COMMITTEE OF THE WHOLE MARCH 22, 2004

SITE DEVELOPMENT FILE DA.04.005 **YORK REGION DISTRICT SCHOOL BOARD**

Site Plan
 Lot 6,
 Concession 7
 APPLICANT:
 YORK REGION DISTRICT
 SCHOOL BOARD

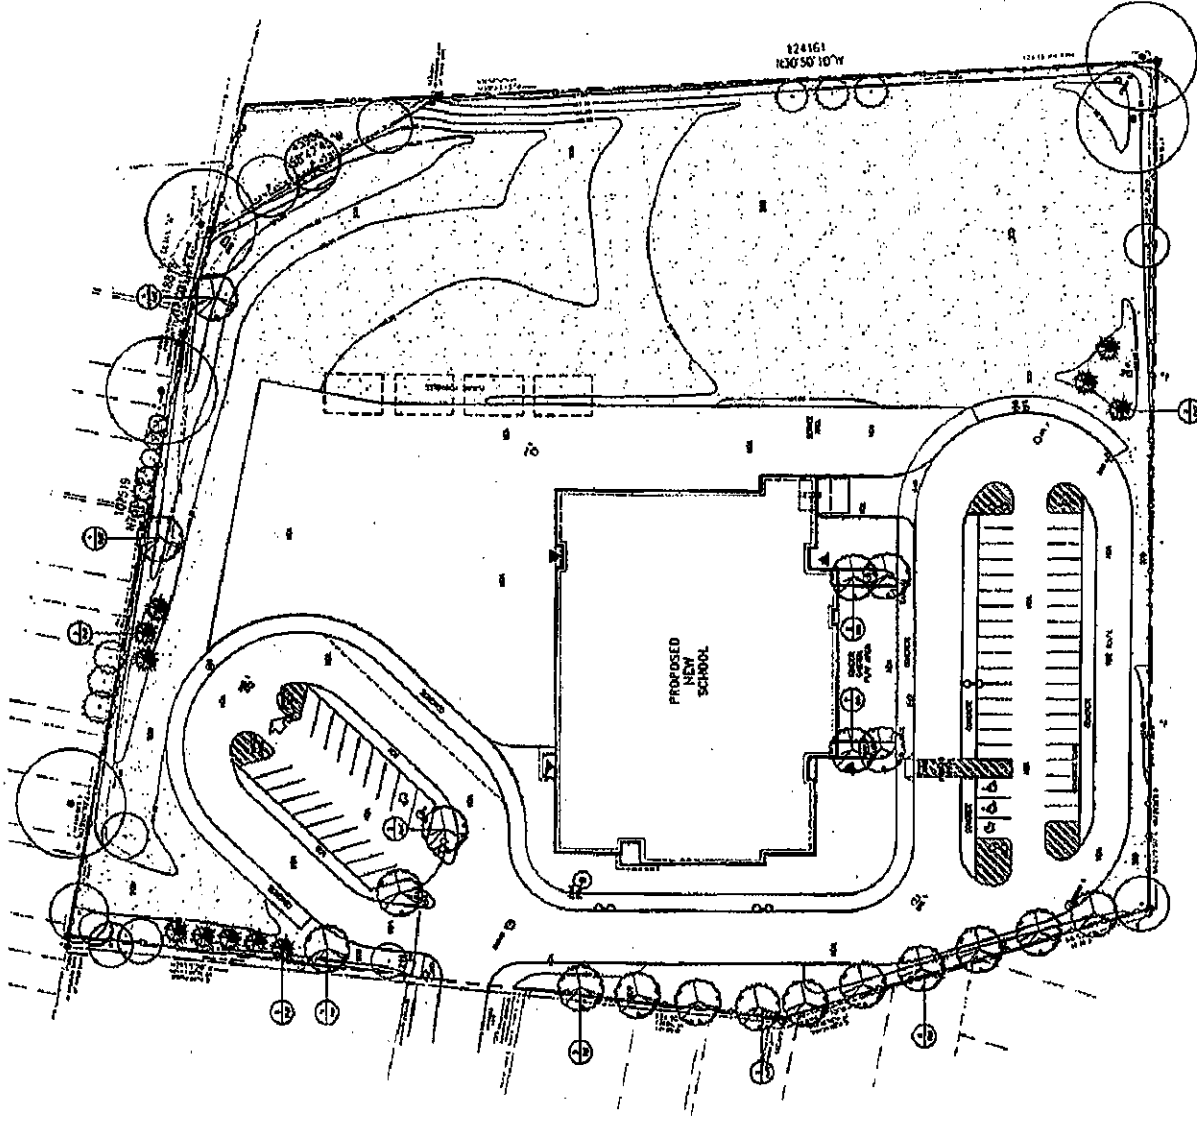
The proposed site plan consists of a 5,268m² 2-storey building located between two parking areas, and is setback a minimum 15m from all residential properties. The main entrance and access point continues to be from Burwick Drive, leading directly to two separate parking areas. The easterly third of the property is comprised of sod, and the remaining two-thirds are comprised of both heavy and medium duty asphalt. A play area is proposed at the south end of the school for kindergarten use, while a play structure has been identified at the southeast corner. Location for 4 future portables has been identified at the northeast portion of the site. The entire site is enclosed with a 1.8m high black vinyl chain link fence.

The site has one access point, from Burwick Drive, a residential feeder off of Kipling Avenue, which leads to a driveway and parking areas. The site has been designed with two separate parking areas; the northern lot serves as both staff parking and a car drop-off, while the southern lot has been designed with a bus loop and drop-off area, separating bus and car movement. The 58 parking spaces are sufficient to serve the school and the future portables. Pedestrian access is anticipated from the sidewalk along Burwick Drive.

- i) the final site plan and building elevations shall be approved by the Urban Design Department.
- ii) the final site servicing and grading plans, stormwater management report, access and on-site vehicular circulation shall be approved by the Engineering Department.
- iii) all Vaughan Hydro and Fire Department requirements shall be fulfilled to the satisfaction of Hydro Vaughan Distribution Inc. and the Vaughan Fire Department, respectively.
- iv) the final landscape plan, including appropriate buffering along the residential lots and detailed landscape cost estimate, shall be approved by the Urban Design Department.
- v) CP Rail shall approve the final plans, prior to issuance of a full building permit.
- vi) all garbage shall be stored indoors until ready to be picked up.

Landscape Plan
 Lot 6,
 Concession 7
 APPLICANT:
 YORK REGION DISTRICT
 SCHOOL BOARD

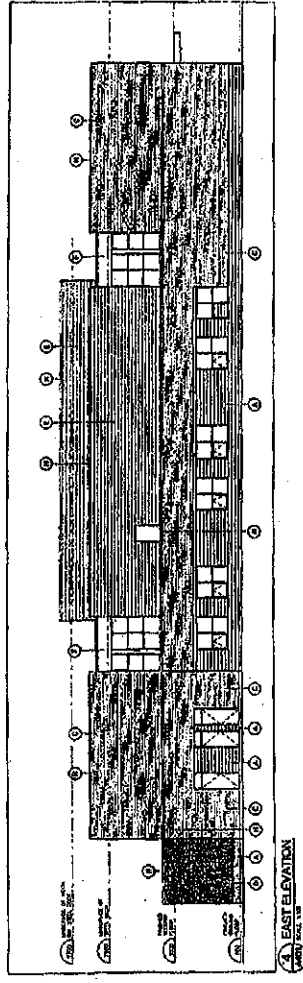
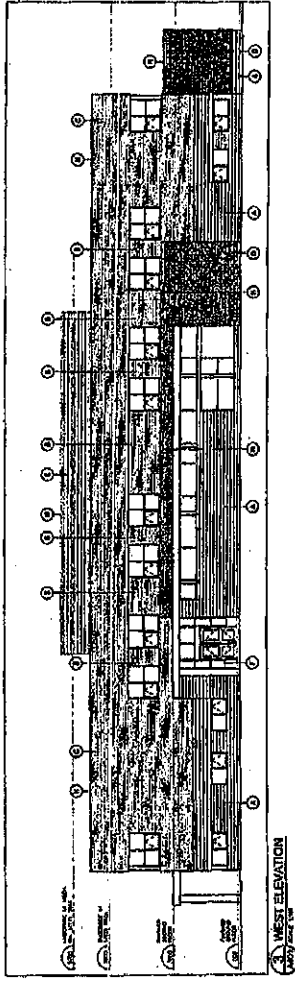
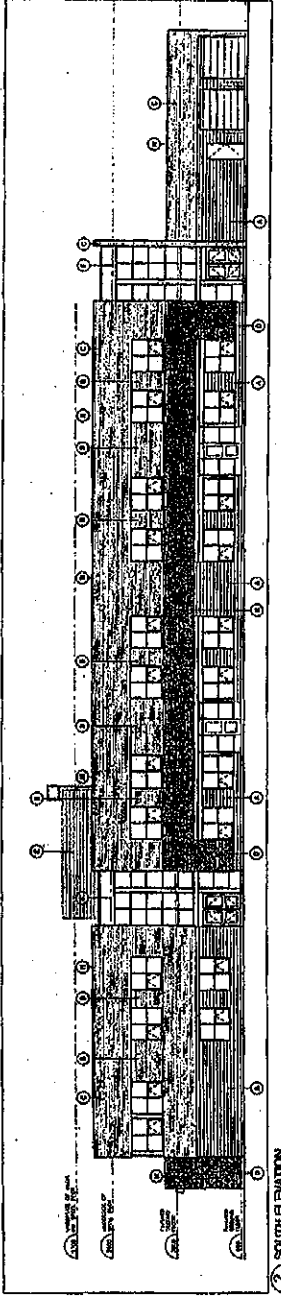
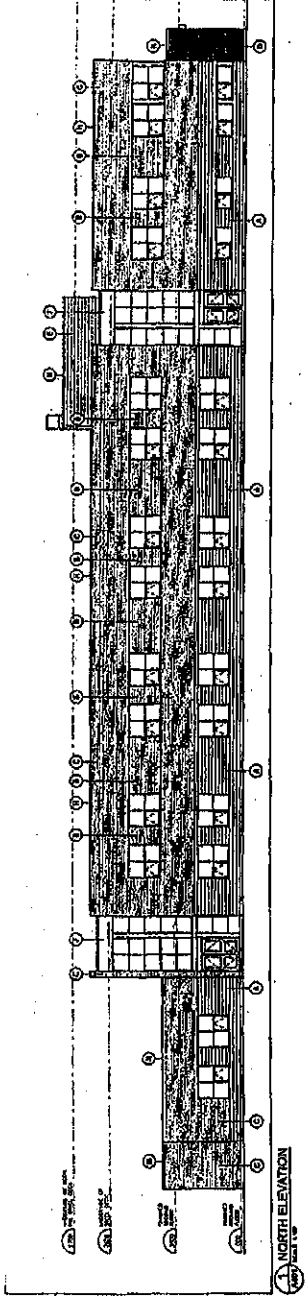
The landscape plan shows a line of deciduous trees along the western lot line abutting the residential lots, but inadequate screening along the northern lot line abutting residential lots. Additional planting in the form of deciduous and coniferous croppings is recommended along the northern lot line to provide the appropriate buffer to the school building, parking and activity areas. A cost estimate detailing the extent of the landscape work is also required prior to final approval.

The Urban Design Department has indicated that the play structure must conform to the latest CSA guidelines for children's play areas and equipment, and that landscaping, specifically along the edges of the site and the adjacent residential properties, needs to be intensified.
